Appl. No. 10/761,393
Amdt. dated September 1, 2005
Reply to Office action of June 21, 2005

In the Drawings:

FIG. 2

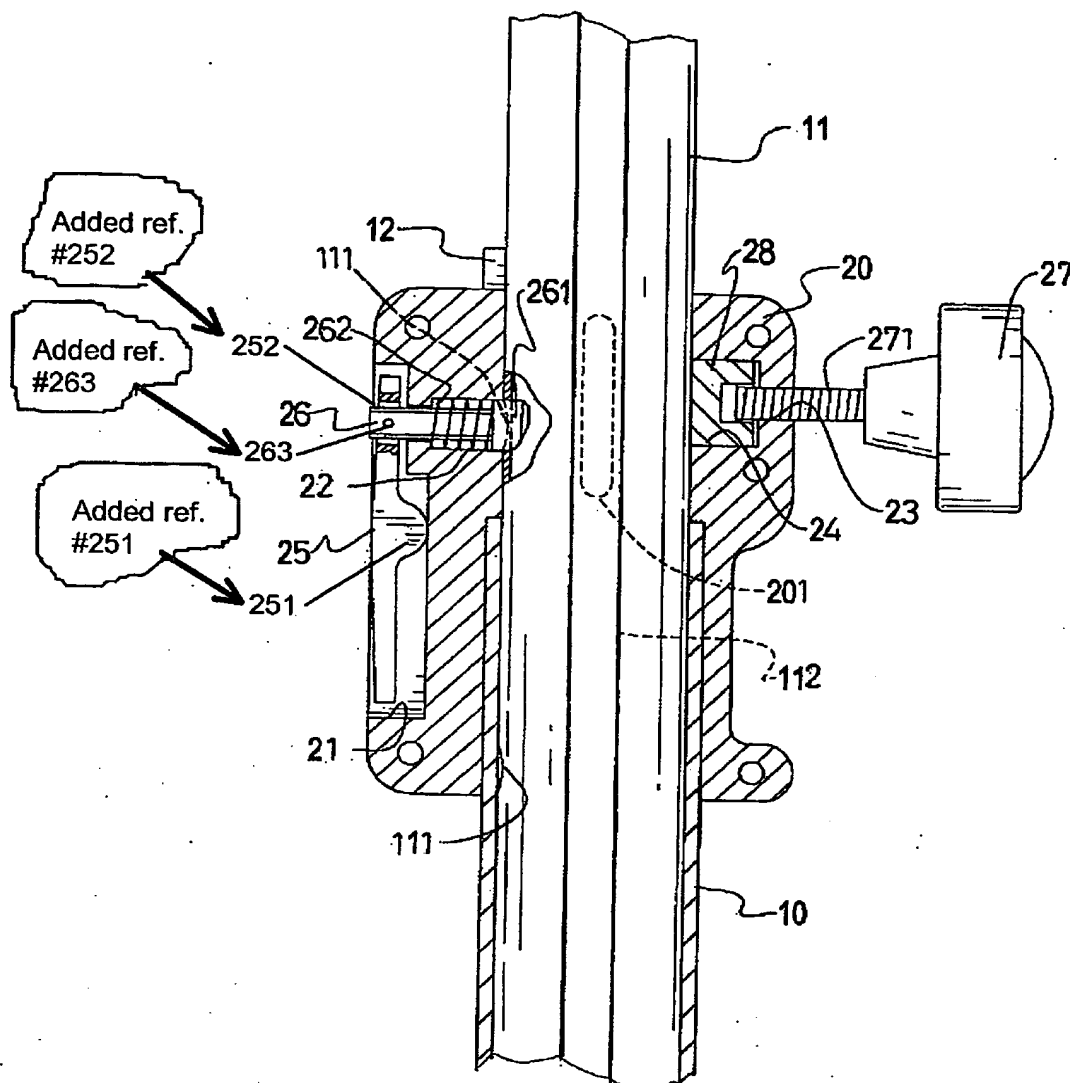
Please amend FIGs. 2 and 3 as indicated on the attached drawing markup sheets. The amendments are to add reference numbers 101, 201 to FIG. 2, and reference number 301 to FIG. 3. Replacement sheets are also provided.
